Plymouth South High School
Plymouth, MA
Ai3 Project # - 1308.00

Addendum #4

June 22, 2015

526 Boston Post Road
 Wayland, MA 01778
 TEL: 508.358.0790
 FAX: 508.358.0791

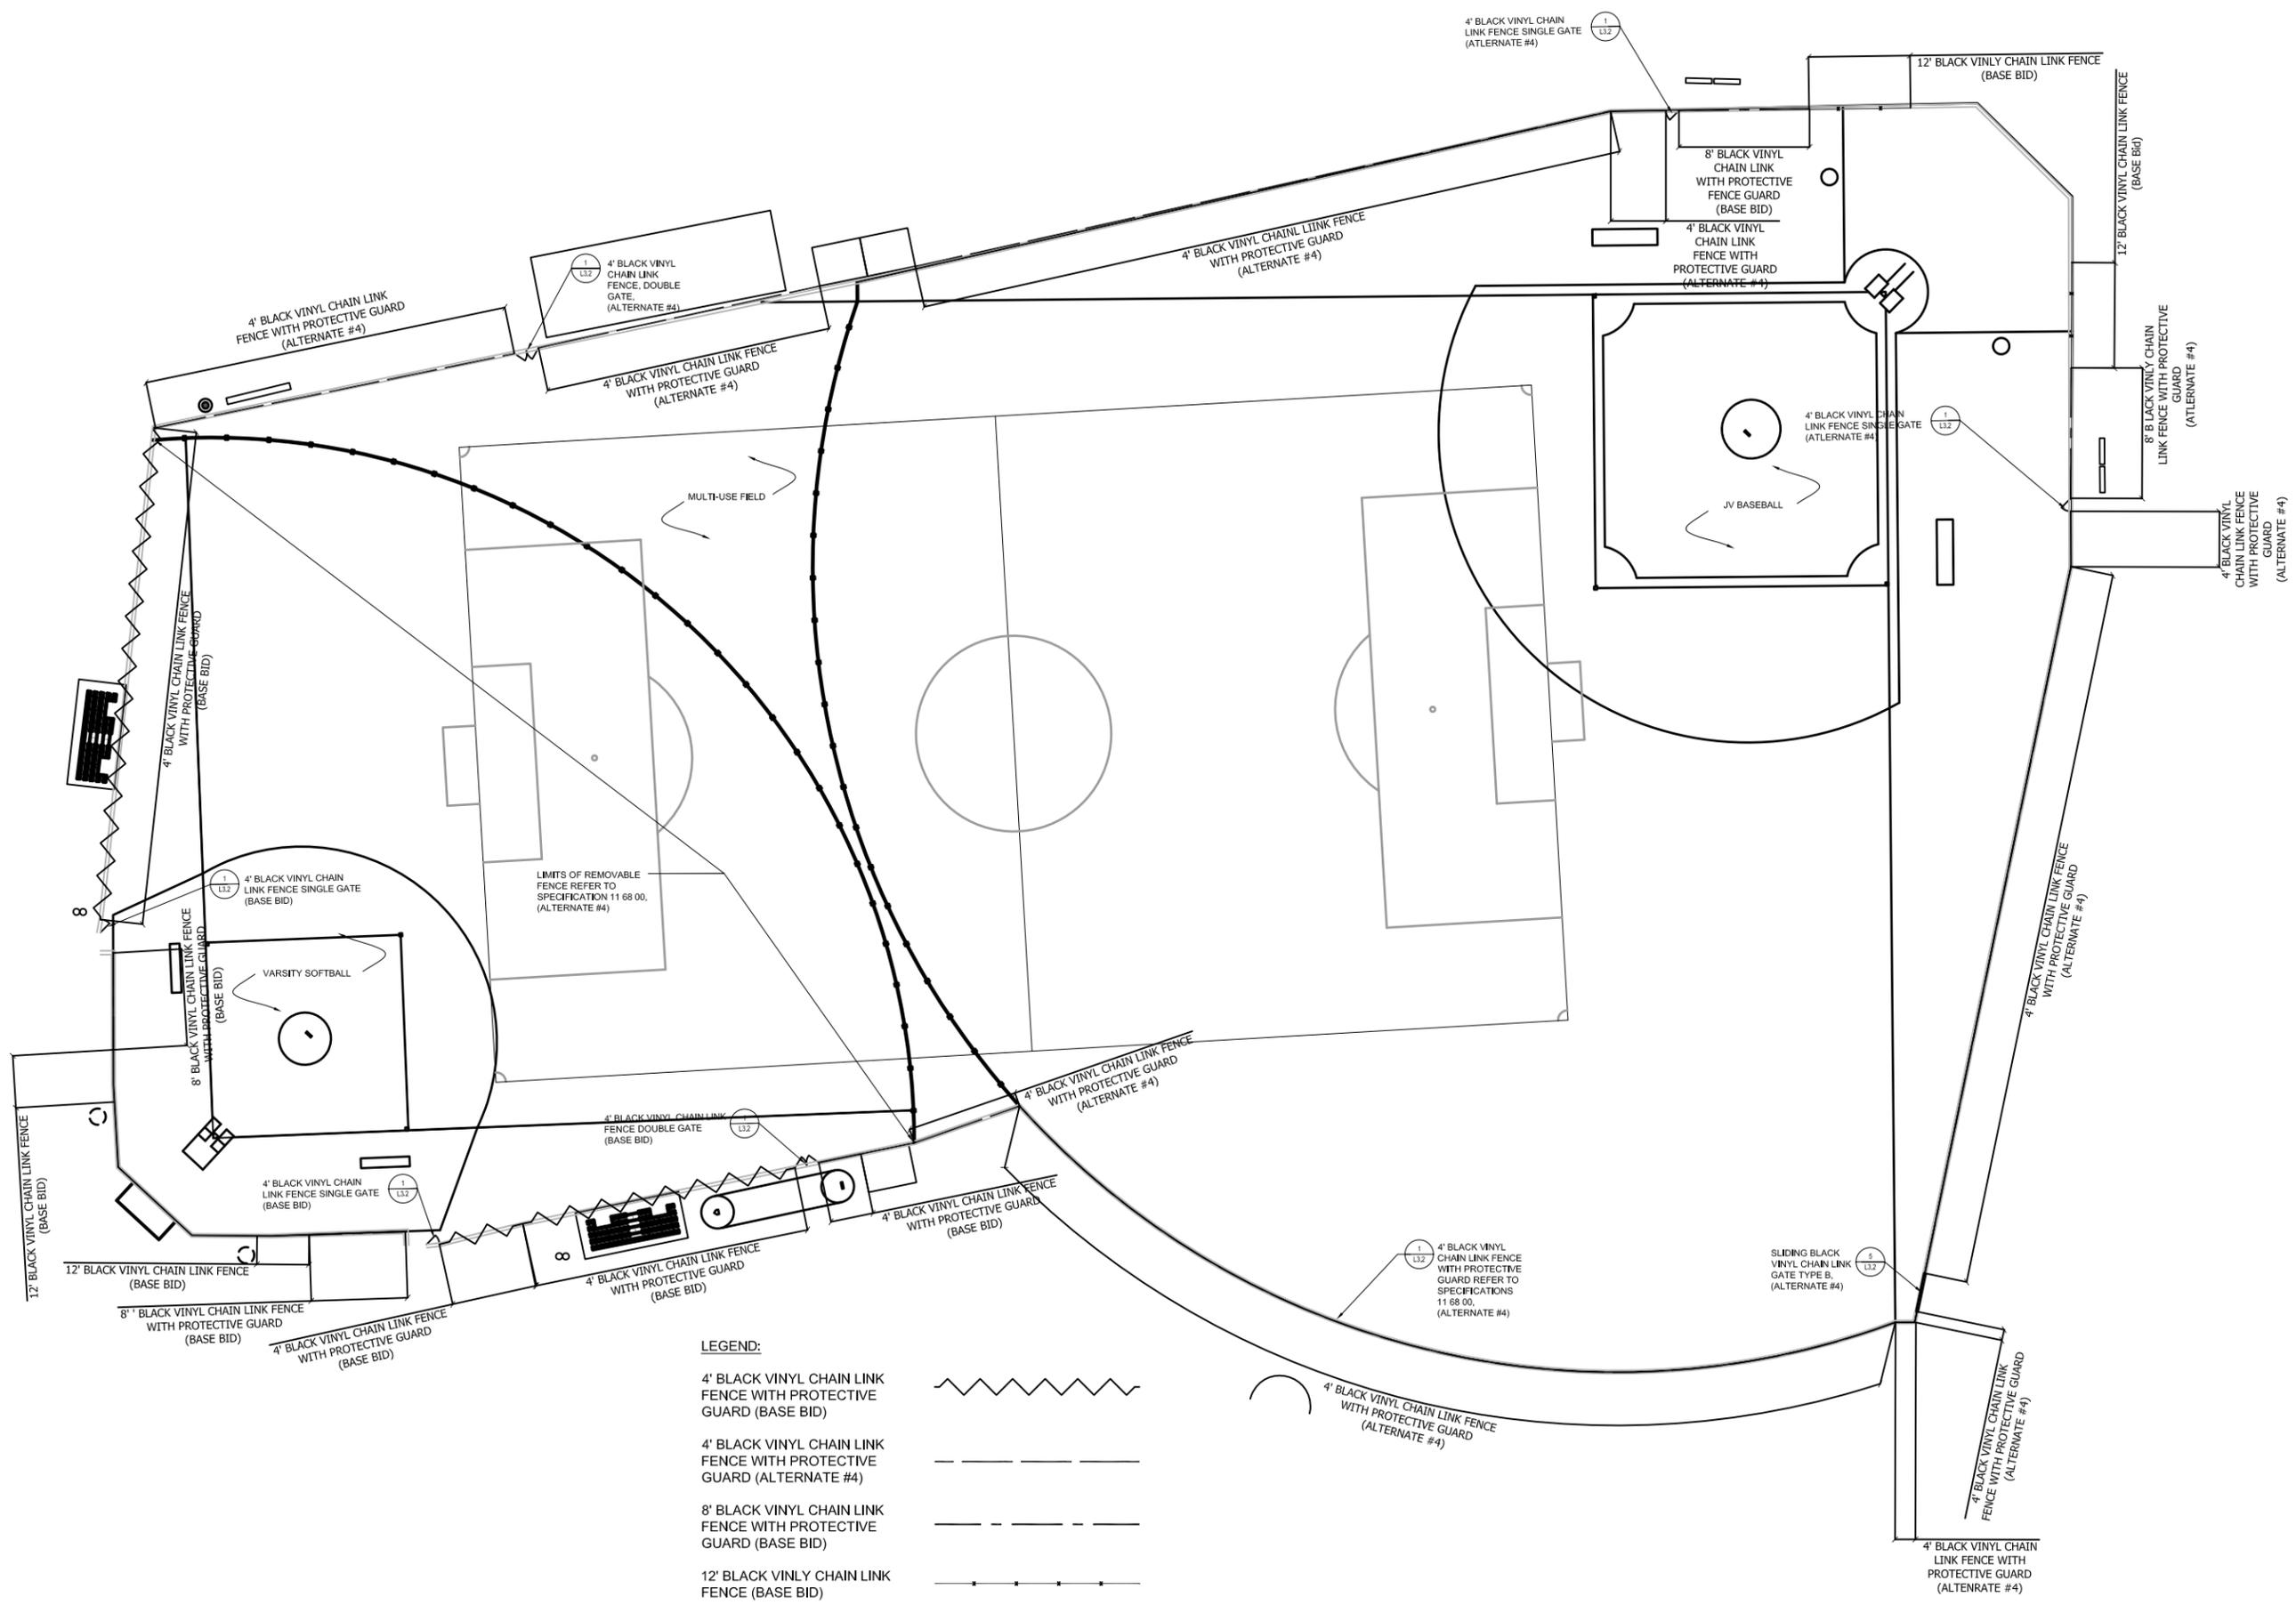
Detail 1 / Varsity Softball Field: Field C; REMOVE "11 69 00" and REPLACE with "11 68 00" on fence call out, per sketch SKL-007 and SKL-008.

REMOVE: "MOBIL ATHLETICS STORAGE UNIT (1) ON CONCRETE PAD SEE SPECIFICATIONS" and REPLACE with "12'x15' STORAGE UNIT (1), REFER TO CIVIL ENGINEERING PLANS AND SPECIFICATIONS" as indicated on SKL-007.

REMOVE: "MOBIL ATHLETICS STORAGE UNITS (2) ON CONCRETE PAD SEE SPECIFICATIONS" and REPLACE with "12'x15' STORAGE UNITS (2), REFER TO CIVIL ENGINEERING PLANS AND SPECIFICATIONS" as indicated on SKL-008.

REVISED all 4' black vinyl chain link fence with protective guard, 8' black vinyl chain link fence with protective guard, and 12' black vinyl chain link fence along the first base foul line and the third base foul line of the varsity softball field shall be part of the base bid as indicated on SKL-009.

REVISED all 8' black vinyl chain link fence with protective guard and 12' black vinyl chain link fence along the first base foul line and third base foul line of the JV baseball field shall be part of the base bid as indicated on SKL-009.

SKA-030
 REF DWG: A9.41

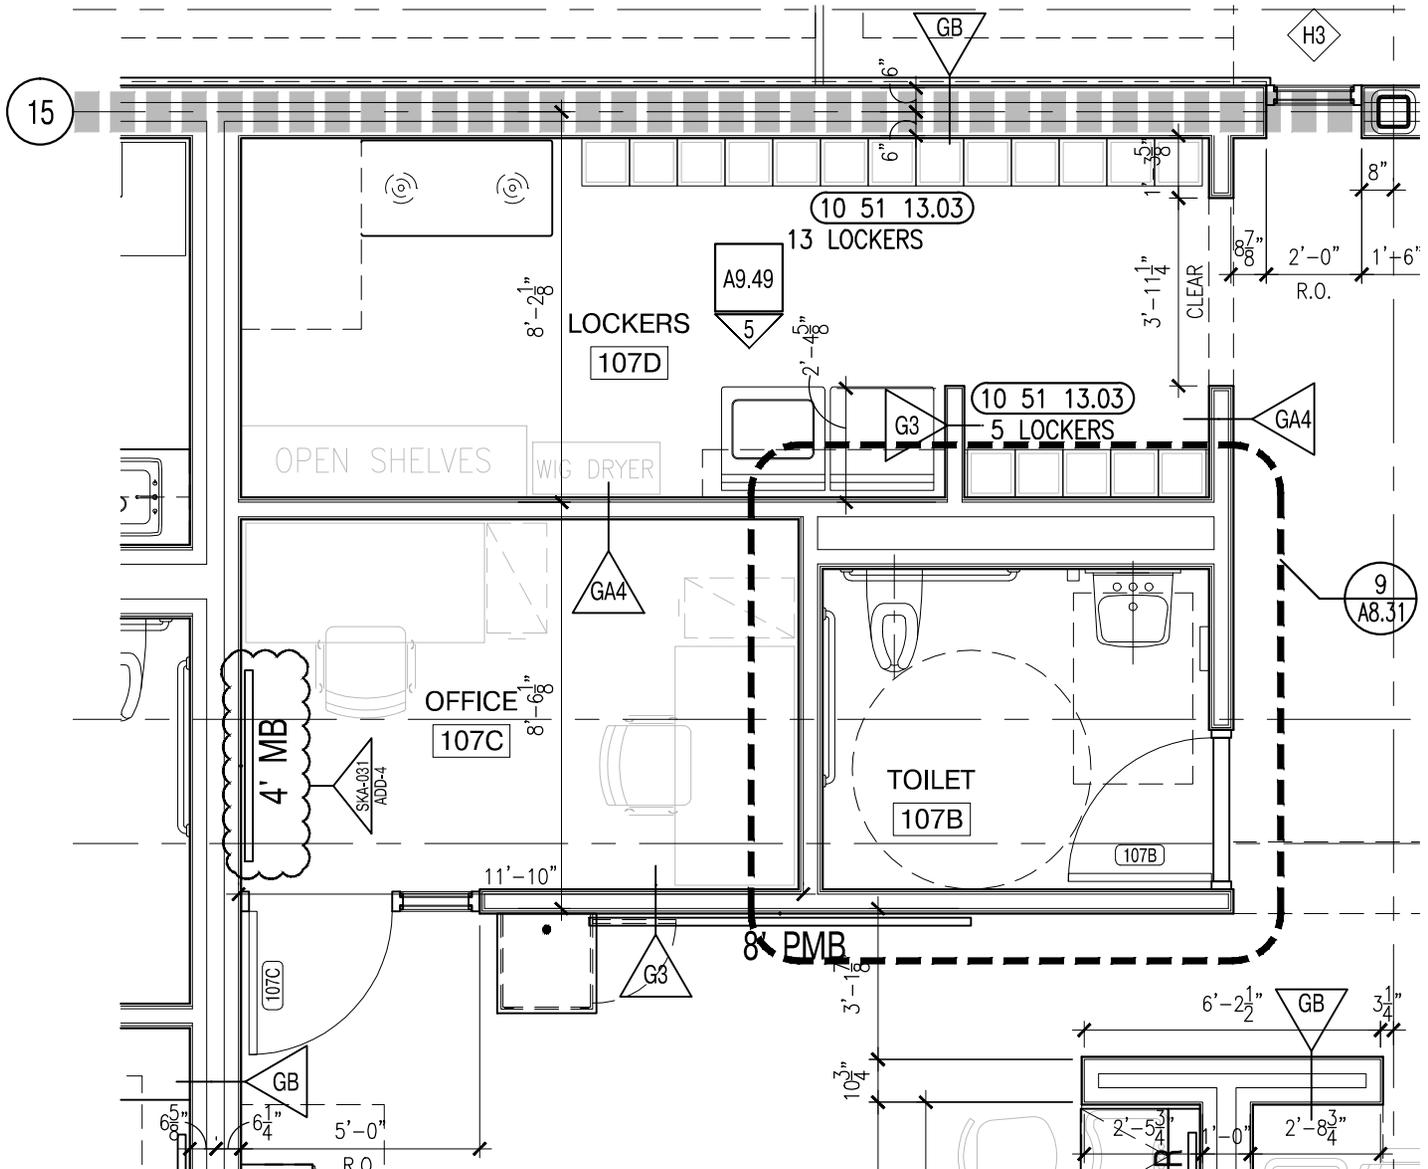
- ADD 4-007 Page 06 20 00-08, Section FINISH CARPENTRY, DELETE Article 2.6 in its entirety.
- ADD 4-008 Page 06 20 00-10, Section FINISH CARPENTRY, Article 2.9,
CLARIFICATION: Refer to Drawing A9.41 – Automotive / Collision Shop Plan for location of Tool Storage Peg Board.
